TECHNICAL SERVICE BULLETIN

Vehicles Equipped With A 2.0L (Panther) Engine – Rattle Type Noise From The Transmission Area At Light Accelerator Input

25-2205

30 June 2025

Figure 1

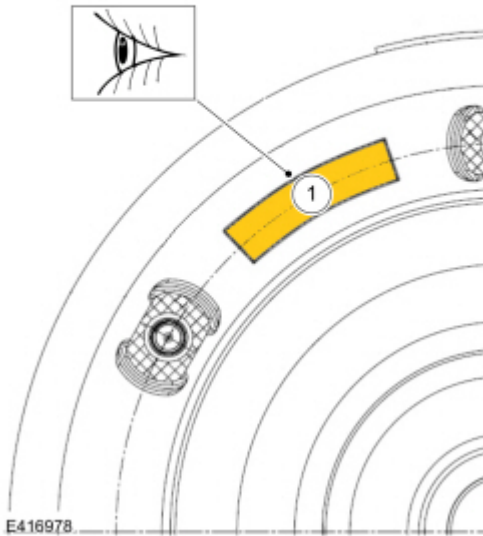
7. Remove the transmission and verify the torque converter part number Prefix and Suffix. Ensure the torque converter part number is JB3P-(7902)-JD or later. If the part number is JB3P-(7902)-JC or earlier, then replace the part with a new torque converter (JD or later). (Figure 1)

Callout 1: Ford Part Number Prefix and Suffix 3mm Max High Here
